**KNOXVILLE/KNOX COUNTY METROPOLITAN PLANNING COMMISSION
 USE ON REVIEW REPORT**

▶ **FILE #:** 4-C-12-UR

▶ **PROPOSED USE:** Modification of the previous condition for a paved access driveway.
 (Case # 5-F-11-UR)

Re: Proposed modification t of roadway conditions to approved UOR 5-F-11-UR

2 PAVEMENT SECTION OPTION 1

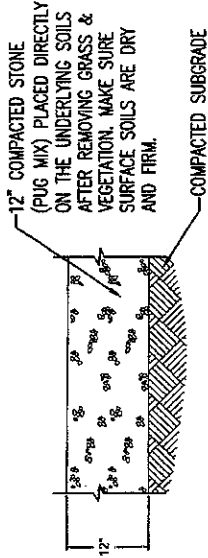
Option #1: Optima will surface access driveway from ROW to Point A, approximately 200-linear feet, with the Knox County Utility Access Driveway cross section detail (compacted sub grade with 4" of base mineral aggregate type A, grade D, 1-3/4" of binder bituminous hot mix grade B-M, and 1-1/4" of topping (asphaltic concrete surfacing grade D). Surface the remainder of the driveway with a compacted 12" aggregate rock base to the WCF.

3 PAVEMENT SECTION OPTION 2

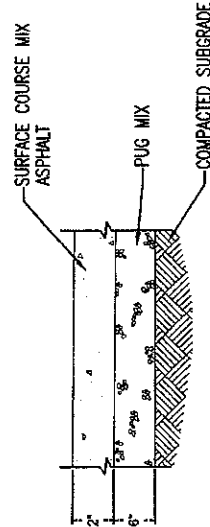
Option #2: Optima will surface access driveway from ROW to Point B, approximately 475-linear feet, with 2" of binder bituminous hot mix grade B-M to conform to IDOT section 404 with 6" of mineral aggregate type "A", grade "D" below. Surface the remainder of the driveway with a compacted 12" aggregate rock base to WCF.
